NMP1L3055
December 3, 2015

Nine Mile Point Nuclear Station, Unit 1
Renewed Facility Operating License No. DPR-63
NRC Docket No. 50-220

Subject: Response to Request for Additional Information - "Application for Technical Specification Change Regarding Risk-Informed Justification for the Relocation of Specific Surveillance Frequency Requirements to a Licensee Controlled Program (Adoption of TSTF-425, Revision 3)"

TABLE 4.6.2a

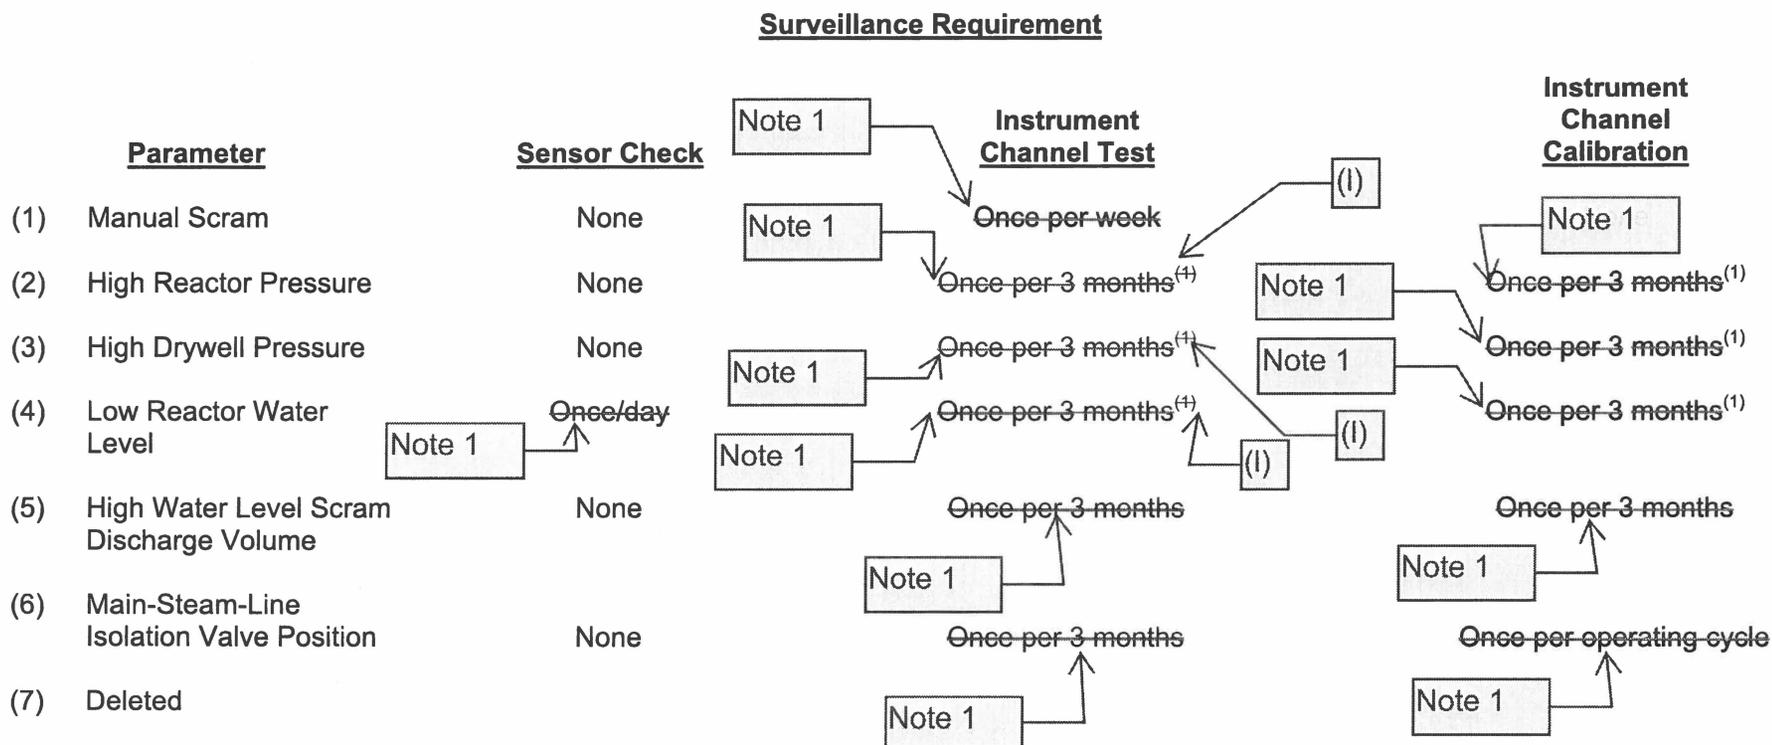
As part of this LAR submittal, several surveillance requirement (SR) frequency changes were proposed in Table 4.6.2a, "INSTRUMENTATION THAT INITIATES SCRAM," (page 201) of the NMP-1 TS. The proposed SR frequency revisions for parameters two through four have a superscript of (1). The NRC staff was unable to locate this note in the TS.

As discussed during the clarification call held on October 26, 2015, provide the supporting note for the proposed change, and modify the submittal as needed to correct the superscript.

As discussed during the clarification call on October 26, 2015, parameters two through four have a superscript of (1). The error was introduced when the TS pages were retyped to clean up several typographical errors for License Amendment 142, approved on July 14, 1993. The superscript (1) is supposed to be (l), the 12th letter of the alphabet, not a number.

Attachment 2 to this letter contains the revised page with the superscript corrected.
